Bexhill to Hastings Link Road Technical Note No.H002A: Reduction in Road Width from 3.5m to 2.5m – CSP H23

April 2010

Single Carriageway

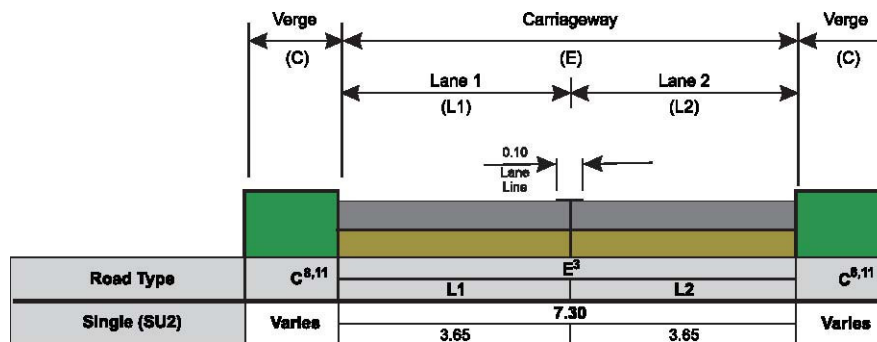
It is proposed to reduce this width to 2.5m as a cost saving measure. The reduced verge width facilitates a reduction in the scale of structures, including Chapel Path Underpass, Woodsgate Bridge and Ninfield Road Retaining walls. Glovers Farm Bridge would also be included in this list but is subject to another alternative design which retains the existing bridge rather than construct a new one.

TD 27/05 of the Highways Agency Design Manual for Roads and Bridges (DMRB) is the Standard used for the design of highway cross sections. The Standard allows a variable width for the verge of a single carriageway road as indicated in the Figure below, the choice of verge width is left to the discretion of the designer taking into account the local factors.

The proposed width of 2.5m is sufficient for all these purposes, particularly as there are no NMU routes at the side of the carriageway on this section of the route.

The proposed 2.5m verge is sufficient to accommodate the services and drainage required for the scheme without becoming congested. Reducing the verges from 3.5m to 2.5m does not compromise the sight lines required by the design standards.
